APPENDIX A

CEDAR VIEWS APARTMENTS – RETROFIT PLAN

PLANNED RETROFITS¹

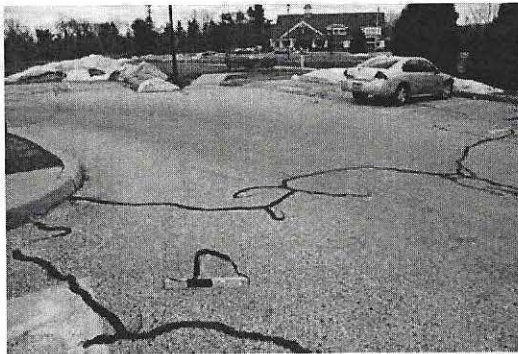
Inaccessible Feature	Photograph(s)	Retrofit(s)
A. Exterior Accessible Route		
Accessible Route – East Entrance		
<p>A.1. Beginning about 15' from the curb ramp at the accessible parking continuing about 10' toward the East Entrance, the cross slope is 3.8%.</p> <p>The 36"-wide accessible route cannot have a cross slope that is more than 2%.</p> <p>(FHA Guidelines, Req. 1 or 2, 4.3.7)</p>	 <p>(DSC01625.jpg)</p>  <p>(DSC01626.jpg)</p>	<p>Remove and replace concrete walkway with no cross slopes exceeding 2%.</p>

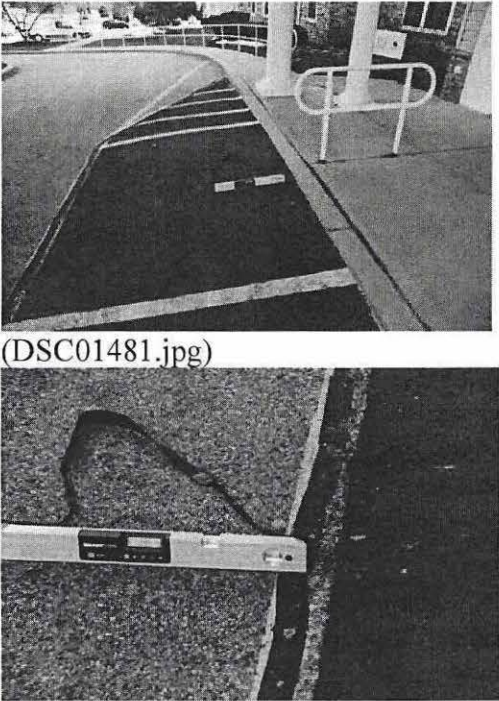
Inaccessible Feature	Photograph(s)	Retrofit(s)
A.2.	<p>The proposed accessible route crosses the vehicular drive heading northeast to the public right of way. The middle section of this crossing has cross slopes that range between 3.4% and 4.3% (see line 23 of the Accessibility Report).</p> <p>Accessible route cannot have a cross slope that is more than 2%.</p> <p>(FHA Guidelines, Req. 1 or 2, 4.3.7; ADA 206.2.1; 403.3)</p>	 <p>(DSC01643.jpg)</p>  <p>(DSC01646.jpg)</p>	<p>Scarify and resurface asphalt paving at crossing.</p>

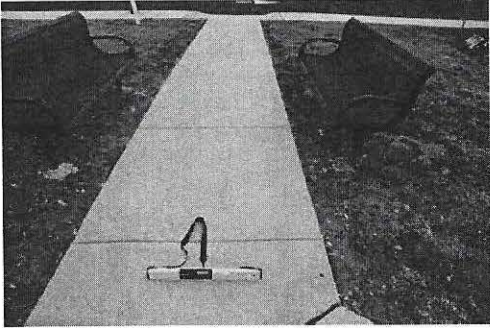
Inaccessible Feature	Photograph(s)	Retrofit(s)
<p>A.3. There is a vertical change of about 3/4" at a joint in the sidewalk (see line 26 of the Accessibility Report).</p> <p>Abrupt changes in level cannot exceed 1/2".</p> <p>(FHA Guidelines, Req. 1 Req. 2, 4.3.8; ADA 206.2.1; 303.2)</p>	 <p>(DSC01660.jpg)</p>  <p>(DSC01661.jpg)</p>	<p>Grind existing concrete paving to bevel the raised edge at 1:12, or replace concrete.</p>

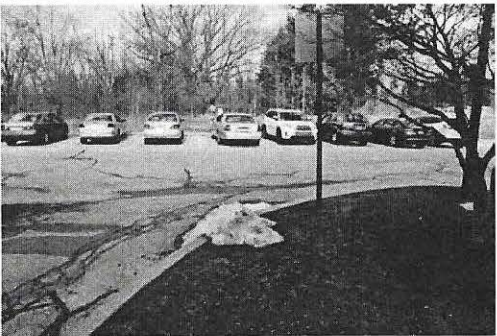
Inaccessible Feature	Photograph(s)	Retrofit(s)
<p>A.4. To the right (north) of the curb ramp at the accessible parking north of the East Entrance, extending for about 10 feet, the cross slope is 6.6% to 7.1% (see line 27 of the Accessibility Report).</p> <p>Accessible route cannot have a cross slope that is more than 2%.</p> <p>(FHA Guidelines, Req. 1 or 2, 4.3.7; ADA 206.2.1; 403.3)</p>	 <p>(DSC01662.jpg)</p>  <p>(DSC01663.jpg)</p>  <p>(DSC01665.jpg)</p>	<p>Remove and replace sidewalk.</p>

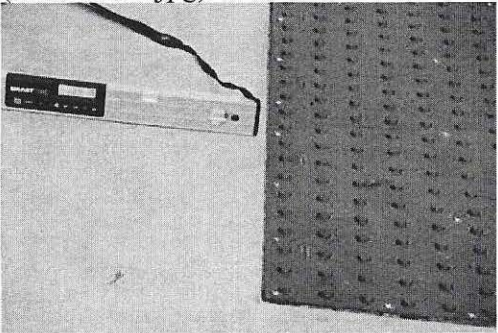
Inaccessible Feature	Photograph(s)	Retrofit(s)
A.5.	<p>Sidewalk at northeast corner of the grounds terminates at a vertical curb. (Route is shown on Accessible Route Diagram; vertical curb not included in Accessibility Report).</p> <p>A continuous accessible route to the public right-of-way is required.</p> <p>(FHA Guidelines, Req. 1 or 2, 4.3.7; ADA 206.2.1; 303.2)</p>	 <p>(DSC01637.jpg)</p>	Install curb ramp.
A.6.	<p>Route from northeast corner of the grounds to the sidewalk leading to Ernest Way crosses the vehicular drive at a diagonal. (Route shown on Accessible Route Diagram; marking for crosswalk not included in Accessibility Report).</p>	 <p>(DSC01641.jpg)</p>	Stripe crossing. Verify cross slopes are maximum 2% at route.

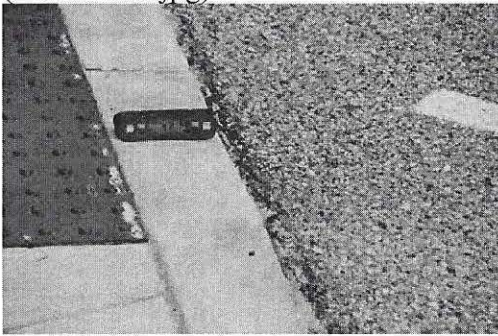
Inaccessible Feature	Photograph(s)	Retrofit(s)
<p>A.7. Beginning about 15' south of the curb ramp at the northeast accessible parking area, continuing about 10' towards the East Entrance, the cross slope is 3.8%. (Route is shown on Accessible Route Diagram; cross slope not included in Accessibility Report).</p> <p>The accessible route cannot have a cross slope that is more than 2%.</p> <p>(FHA Guidelines, Req. 1 or 2, 4.3.7; ADA 206.2.1; 403.3)</p>	 <p>(DSC01625.jpg)</p>  <p>(DSC01626.jpg)</p>	<p>Remove and replace sidewalk.</p>

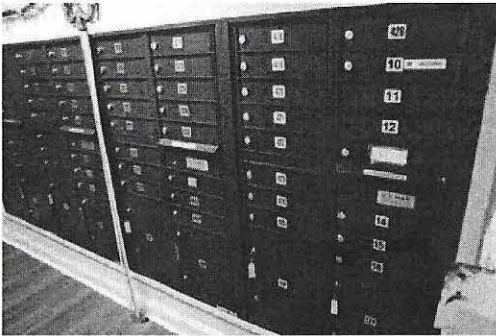
Inaccessible Feature	Photograph(s)	Retrofit(s)
<p>A.11. The accessible route turns on the curb ramp at the East Entrance. Therefore, the curb ramp creates a cross slope of 10.4%.</p> <p>Accessible route cannot have a cross slope that is more than 2%. Where the accessible route turns, the cross slope is measured in two directions.</p> <p>(FHA Guidelines, Req. 1 or 2, 4.3.7; ADA 206.2.1; 403.3)</p>	 <p>(DSC01618.jpg)</p>  <p>(DSC01620.jpg)</p>	<p>Remove and replace concrete walkway and curb ramp with no cross slopes exceeding 2%.</p>

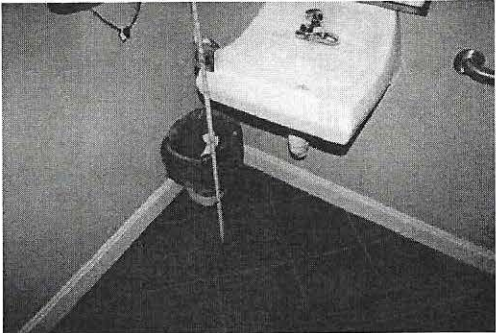
Inaccessible Feature	Photograph(s)	Retrofit(s)
B.2.	<p>There are approximately 5 tables with chairs in the first floor common areas. The knee and toe space under every table is blocked by the pedestal support.</p> <p>At least 5% of the tables must provide accessible wheelchair spaces. A compliant wheelchair space must provide clear floor space under the table that is at least 30" wide, 27" high, and 17" deep.</p> <p>(FHA Guidelines Req. 2, 4.30)</p>	 <p>(DSC01457.jpg)</p>	<p>Replace one or more table(s) with table(s) that provide the required clear floor space.</p>

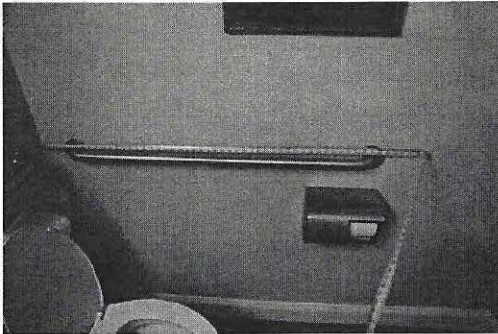
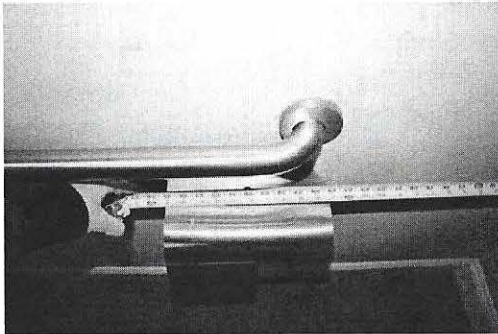
Inaccessible Feature	Photograph(s)	Retrofit(s)
First Floor Restroom		
<p>B.4. The maneuvering space beside the latch side of the door to the first floor restroom extends 4".</p> <p>The pull side of the door requires a forward approach. Therefore, the maneuvering space must be 60" deep and must extend 18" to the side of the latch.</p> <p>(ADA Standards 4.1.3(7)&(8), 4.13.6, FHA Guidelines Req. 2, 4.13.6)</p>	 <p>(DSC01423.jpg)</p> <p>(DSC01427.jpg)</p>	<p>Reverse direction of door swing to allow for required maneuvering space.</p>

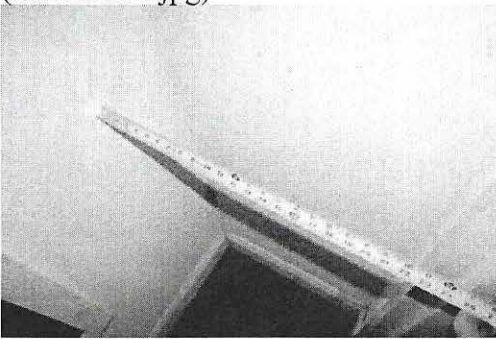
Inaccessible Feature	Photograph(s)	Retrofit(s)
B.5.	<p>The door to the first floor restroom has a closer and the maneuvering space extends 3 3/4" to the latch side.</p> <p>A forward approach to the push side of the door is required. The door has a latch. If it has a closer, then, the maneuvering space must extend 12" to the latch side of the door.</p> <p>(ADA Standards 4.1.3(7)&(8), 4.13.6, FHA Guidelines Req. 2, 4.13.6)</p>	 <p>(DSC01431.jpg)</p>  <p>(DSC01456.jpg)</p>	Reverse direction of door swing to allow for required maneuvering space.

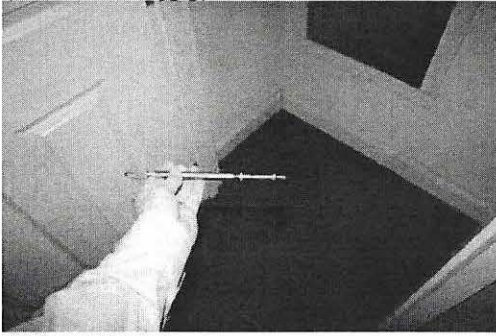
Inaccessible Feature	Photograph(s)	Retrofit(s)
B.7.	<p>The top of the wall-hung lavatory in the first floor restroom is 35" above the floor.</p> <p>Top of the lavatory and counter cannot be higher than 34".</p> <p>(ADA Standards 4.1.3(11), 4.19.2, FHA Guidelines Req. 2, 4.19.2.2)</p>	 <p>(DSC01441.jpg)</p>  <p>(DSC01442.jpg)</p>	<p>Lower lavatory so that the top is no higher than 34".</p>

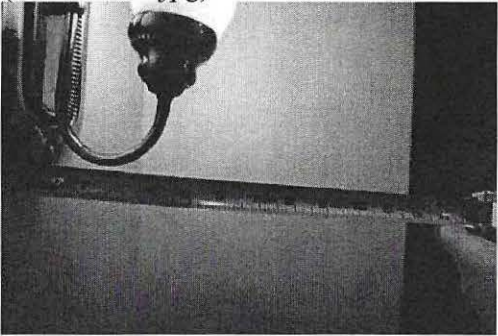
Inaccessible Feature	Photograph(s)	Retrofit(s)
<p>B.8. The soap and hand sanitizer dispensers in the first floor restroom reduce the clear space above the rear grab bar to about 11".</p> <p>There must be at least 12" of clear space above the grab bar.</p> <p>(ADA Standards 4.1.3(11), 4.26.2, FHA Guidelines Req. 2, 4.24.2)</p>	 <p>(DSC01443.jpg)</p>  <p>(DSC01445.jpg)</p>	<p>Relocate the soap and hand sanitizer dispensers to allow required clear space above the rear grab bar.</p>

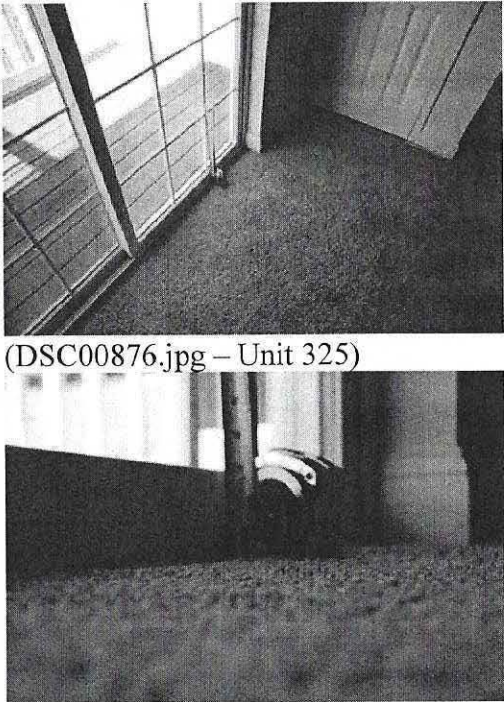
Inaccessible Feature	Photograph(s)	Retrofit(s)
Trash Rooms (4 in the building)		
<p>B.11. The corridor doors to the trash chutes have closers and the maneuvering space is 24" deep and extends less than 12" to the latch side.</p> <p>A forward approach to the push side of the door is required. The door has a latch. If it has a closer, then, the maneuvering space must extend 12" to the latch side of the door.</p> <p>(FHA Guidelines Req. 2, 4.13.6)</p>	 <p>(DSC00955.jpg)</p>  <p>(DSC00956.jpg)</p>	<p>Replace door closers with delay-action closers.</p>

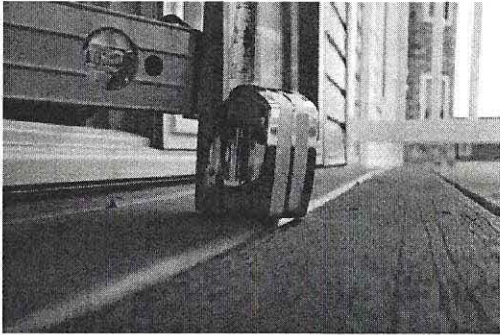
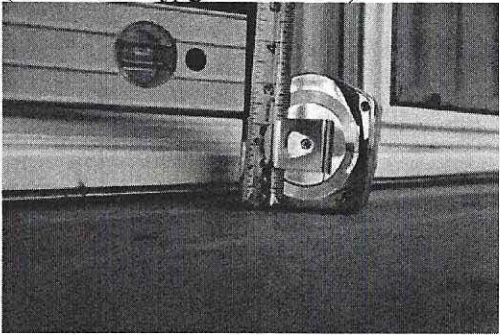
Inaccessible Feature	Photograph(s)	Retrofit(s)
B.12.	<p>The corridor doors to the trash chutes require 11 pounds force.</p> <p>Common use interior doors must be openable with no more than 5 pounds force. Fire doors must be openable with the minimum opening force permitted by the local building/fire official.</p> <p>(FHA Guidelines Req. 2, 4.13.11)</p>	 <p>(DSC00960.jpg)</p>	<p>Replace door closers with delay-action closers that require no more than 5 pounds force.</p>

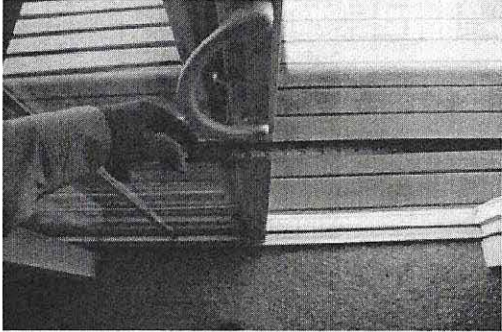
Inaccessible Feature	Photograph(s)	Retrofit(s)
B.13.	<p>In the trash rooms, the control on the trash chute intake door requires 10 to 11 pounds force.</p> <p>The control for the trash chute intake door must be openable with no more than 5 pounds force.</p> <p>(FHA Guidelines Req. 2, 4.25.4)</p>	 <p>(DSC00958.jpg)</p>  <p>(DSC00959.jpg)</p>	<p>If feasible, adjust the chute intake doors to reduce the amount of force required for operation.</p>

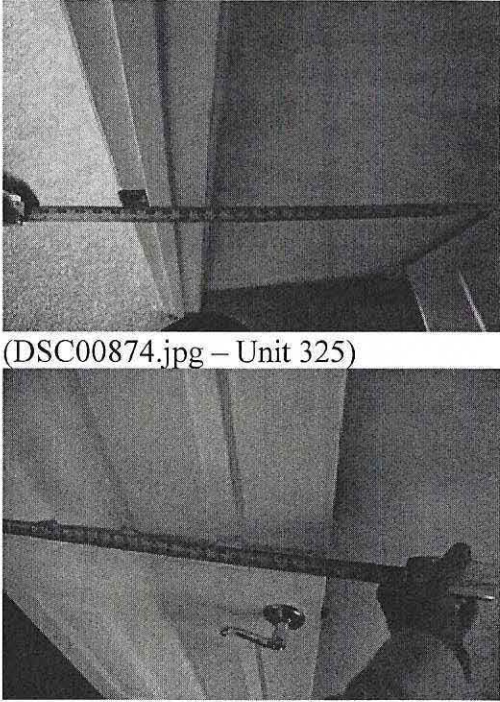
Inaccessible Feature	Photograph(s)	Retrofit(s)
<p>C.2. At upper level units with pervious decks, the tops of the balcony thresholds are more than 1 1/4" above the balcony.</p> <p>A balcony or terrace with a pervious surface, such as wood or pavers on pedestals, cannot be more than 1/2" below the interior finish floor. The top of the threshold cannot be more than 1 1/4" above the terrace.</p> <p>(FHA Guidelines Req. 4(5))</p>	 <p>(DSC00880.jpg – Unit 325)</p>  <p>(DSC00928.jpg – Unit 328)</p>	<p>Purchase and keep on hand in the management office, a minimum of 2 ramps suitable for installation at 1 1/2", 2", and 2 1/2" high thresholds (total of 6).</p> <p>Post a laminated notice inside the kitchen sink base notifying residents that ramps are available to residents on request. Submit product and wording for notice to DOJ for review and approval prior to purchasing products and printing notices.</p>

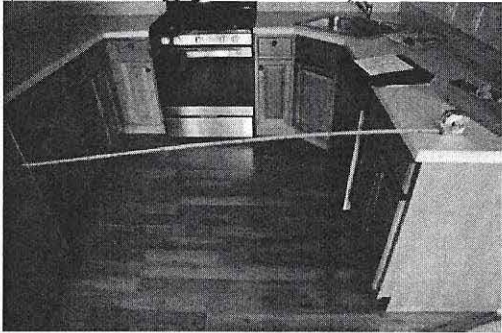
Inaccessible Feature	Photograph(s)	Retrofit(s)
<p>C.3. At units at grade (with concrete patios), the surfaces of the patios are more than 4 3/4" below the top of the threshold.</p> <p>In the dwelling unit, the impervious balcony surface may be up to 4" below the finish floor and 4 3/4" below the top of the threshold.</p> <p>(FHA Guidelines Req. 4(4))</p>	 <p>(DSC01168.jpg – Unit 124)</p>	<p>Post a laminated notice inside the kitchen sink base notifying residents that property management will provide a raised deck surface with pervious decking on request. Submit wording for notice to DOJ for review and approval prior to purchasing products and printing notices.</p> <p>Raised deck to match the size and shape of the existing patio surface and be set no more than 1/2" lower than the interior floor.</p> <p>(Note: This issue does not apply to Unit 326.)</p>
<p>C.4. Balcony and patio doors clear openings widths are less than 31 5/8".</p> <p>The sliding door clear opening must be at least a nominal 32" (31 5/8").</p> <p>(FHA Guidelines Req. 3(2))</p>	 <p>(DSC00879.jpg – Unit 325)</p>	<p>No retrofit required for sliding doors with clear openings of at least 31".</p> <p>For sliding doors with clear openings of less than 31", adjust or modify door stop to widen opening to a minimum width of 31 1/2".</p>

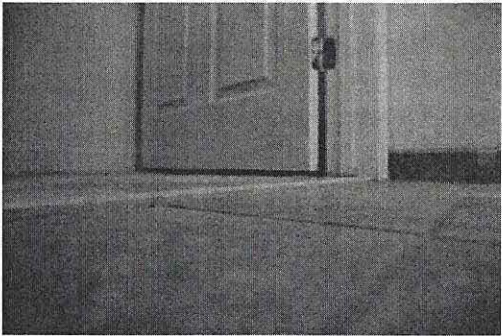
Inaccessible Feature	Photograph(s)	Retrofit(s)
Type B – 1 Bedroom, 1 Bath (2 Units of this Type) (Surveyed Units: 419 and 421)		
<p>D.3. The coat closet is more than 24" deep and the clear opening is 21 1/2".</p> <p>If the closet is deeper than 24", the closet door is intended for user passage. It must provide at least 31 5/8" clear opening.</p> <p>(FHA Guidelines Req. 3(2))</p>	<p>No photos taken.</p>	<p>If feasible (i.e., where the closet is at least 36" wide) remove door and install cased opening to provide at least 31 5/8" clear opening.</p> <p>If not feasible, post laminated notice in the closet notifying the resident that closet fittings (shelves and hanging rod/bar) can be relocated or depth of closet reduced to 24" on request of the resident. Submit wording for notice to DOJ for review prior to printing notice.</p>

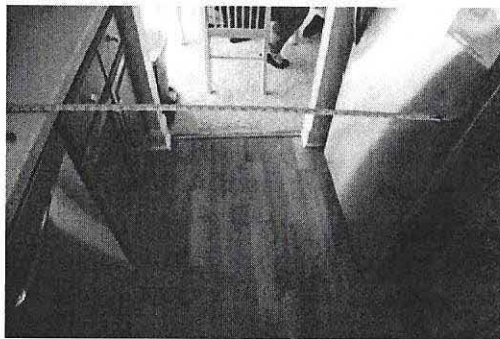
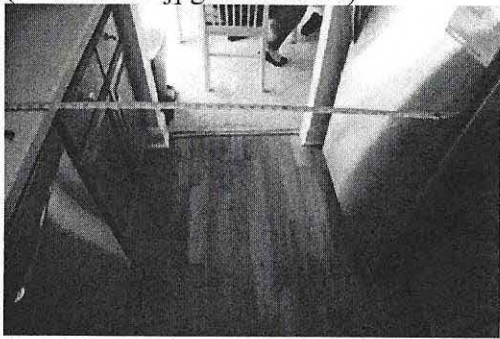
Inaccessible Feature	Photograph(s)	Retrofit(s)
<p>D.4. The U-shaped kitchen in Unit 419 is about 44" wide at the refrigerator and 52 1/2" in front of the range. Similarly, the U-shaped kitchen in Unit 421 is about 46" wide at the refrigerator and 52 1/2" in front of the range. Therefore, a 60" turning circle does not fit in either unit.</p> <p>There is a kitchen sink in the base of the U-shaped kitchen. It requires a parallel clear floor space. Therefore, the kitchen must accommodate a 60"-diameter turning circle.</p> <p>(FHA Guidelines Req. 7(1)(b))</p>	 <p>(DSC01255.jpg – Unit 419)</p> <p>(DSC01257.jpg – Unit 419)</p>	<p>Design the reconfiguration of the kitchen to provide a compliant forward approach to the sink with removable cabinet and submit the design to DOJ for approval. Renovate the kitchens consistent with the approved design, including necessary repair or replacement of finishes, flooring, and counter supports.</p>

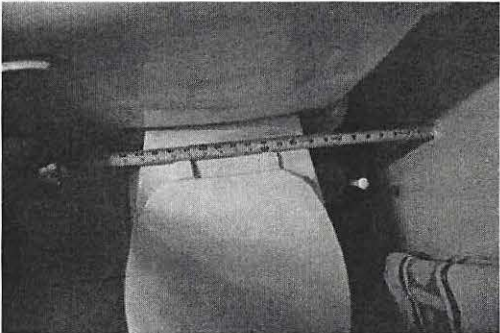
Inaccessible Feature	Photograph(s)	Retrofit(s)
D.5.	<p>The kitchen sink is located in a corner and has a base cabinet. The parallel clear floor space is about 16 1/2" wide.</p> <p>Clear floor space at the kitchen sink must be at least 30" by 48" and centered.</p> <p>(FHA Guidelines Req. 7(1)(a))</p>	 <p>(DSC01259.jpg – Unit 419)</p>	<p>Design the reconfiguration of the kitchen to provide a compliant parallel or forward approach and submit the design to DOJ for review and approval. Include removable sink base if forward approach is used. Renovate the kitchens consistent with the approved design, including necessary repair or replacement of finishes, flooring, and counter supports.</p>
D.6.	<p>The threshold to the bathroom is about 1/2" tall and is not beveled 1:2 on the bathroom side.</p> <p>The dwelling unit entrance is in an interior corridor. The threshold cannot be taller than 1/2". Where the top of the threshold is more than 1/4" above the landing, the transition must be beveled at least 1:2.</p> <p>(FHA Guidelines Req. 4(4))</p> <p>(Note: This issue was observed in Unit 421 but not in Unit 419.)</p>	 <p>(DSC01274 – Unit 421)</p>	<p>Modify or replace threshold so that it is no taller than 1/2" and, if necessary, beveled at least 1:2 with a vertical edge that is no taller than 1/4".</p>

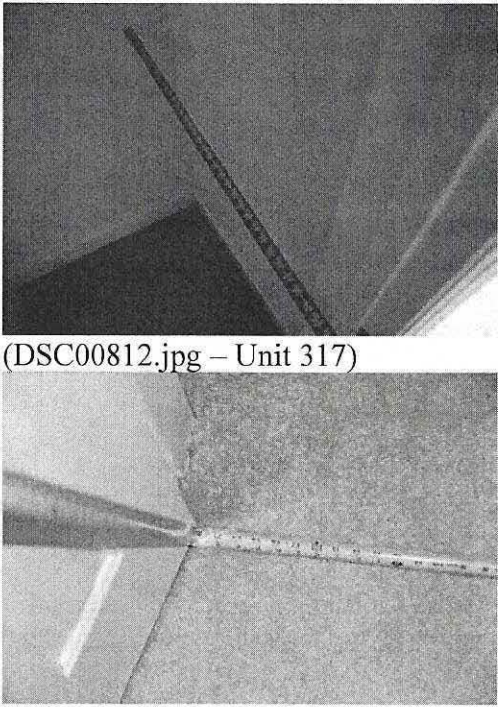
Inaccessible Feature	Photograph(s)	Retrofit(s)
D.9.	<p>At the powder room door, the top of the threshold is 1/2". It is not beveled.</p> <p>The dwelling unit entrance is in an interior corridor. The threshold cannot be taller than 1/2". Where the top of the threshold is more than 1/4" above the landing, the transition must be beveled at least 1:2.</p> <p>(FHA Guidelines Req. 4(4))</p> <p>(Note: This issue was observed in Unit 214 but not in Unit 230.)</p>	 <p>(DSC01342.jpg – Unit 214)</p>	<p>Modify or replace threshold so that it is no taller than 1/2" and, if necessary, beveled at least 1:2 with a vertical edge that is no taller than 1/4".</p>

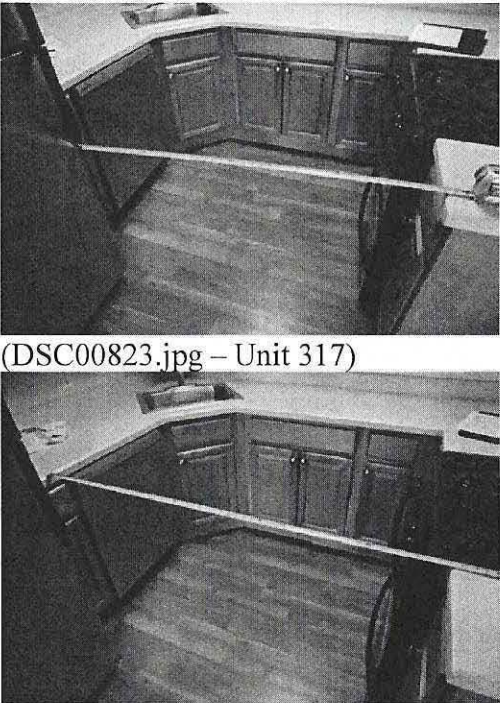
Inaccessible Feature	Photograph(s)	Retrofit(s)
<p>D.10. The clearance between the refrigerator and the counter is 37 1/2" in Unit 214 and 36 3/4" in Unit 230.</p> <p>Clearance between opposing counters, cabinets, appliances, and walls must be at least 40".</p> <p>(FHA Guidelines Req. 7(1)(b))</p>	 <p>(DSC01349.jpg – Unit 214)</p>  <p>(DSC01181.jpg – Unit 230)</p>	<p>Upon request, replace refrigerator with counter-depth unit that provides at least 40" clearance.</p> <p>Post permanent notice in the sink base cabinet notifying residents that a counter-depth unit is available on request. Notice may include information concerning the difference in cubic feet of storage space between the existing refrigerator and the one which will be provided. Submit wording for notice to DOJ for review and approval prior to and printing notice.</p>

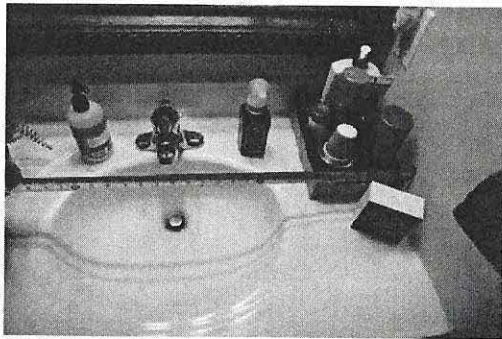
Inaccessible Feature	Photograph(s)	Retrofit(s)
D.20.	<p>The threshold to the hall bathroom, where the laundry equipment is located, is 1/2" tall and is not beveled 1:2 on the bathroom side.</p> <p>The dwelling unit entrance is in an interior corridor. The threshold cannot be taller than 1/2". Where the top of the threshold is more than 1/4" above the landing, the transition must be beveled at least 1:2.</p> <p>(FHA Guidelines Req. 4(4))</p>	 <p>(DSC01053.jpg – Unit 17)</p>	<p>Modify or replace threshold so that it is no taller than 1/2" and, if necessary, beveled at least 1:2 with a vertical edge that is no taller than 1/4".</p>
D.21.	<p>The kitchen sink is located in a corner and has a base cabinet. The parallel clear floor space is about 16 1/2" wide.</p> <p>Clear floor space at the kitchen sink must be at least 30" by 48" and centered.</p> <p>(FHA Guidelines Req. 7(1)(a))</p>	 <p>(DSC01082.jpg – Unit 17)</p>	<p>Design the reconfiguration of the kitchen to provide a compliant parallel or forward approach and submit the design to DOJ for review and approval. Include removable sink base if forward approach is used. Renovate the kitchens consistent with the approved design, including necessary repair or replacement of finishes, flooring, and counter supports.</p>
